Gunite Hub Installation

Gunite has released a series of new part numbers for the Gunite-Lite brake drum product line. These new part numbers are for use with aluminum hubs only.

GUNITE Service Bulletin

Figure 6 *Gunitite-Lite drum with .91" mounting hole for use with aluminum hub.*

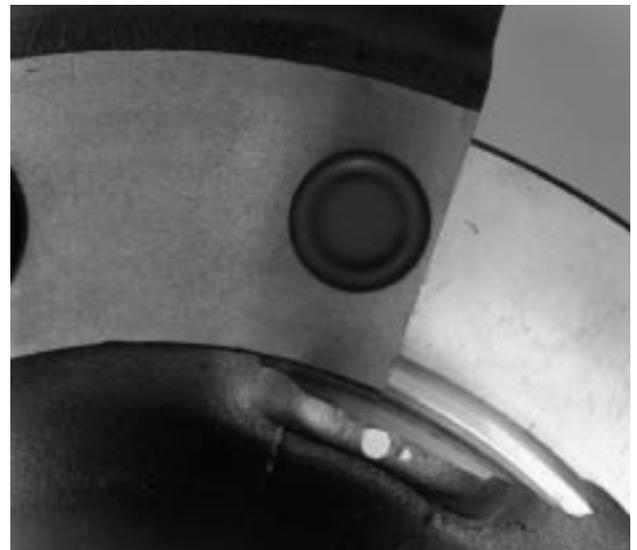
The new Gunitite-Lite brake drums are manufactured with .91" mounting holes to help center the drum and keep it off of the wheel pilot during installation. Because of the smaller mounting hole, the new Gunitite-Lite brake drums provide better alignment with the drum pilot resulting in less chance of the drum being cocked during wheel installation and less potential for damage to the drum pilot on the aluminum hub.

WARNING: Gunitite-Lite brake drums with .91" mounting holes are for use with aluminum hubs only. These brake drums should NOT be used with steel or ductile iron hubs. Use of the Gunitite-Lite brake drum with the .91" hole on a steel or ductile iron hub may cause interference between the mounting hole and the wheel bolt during installation.
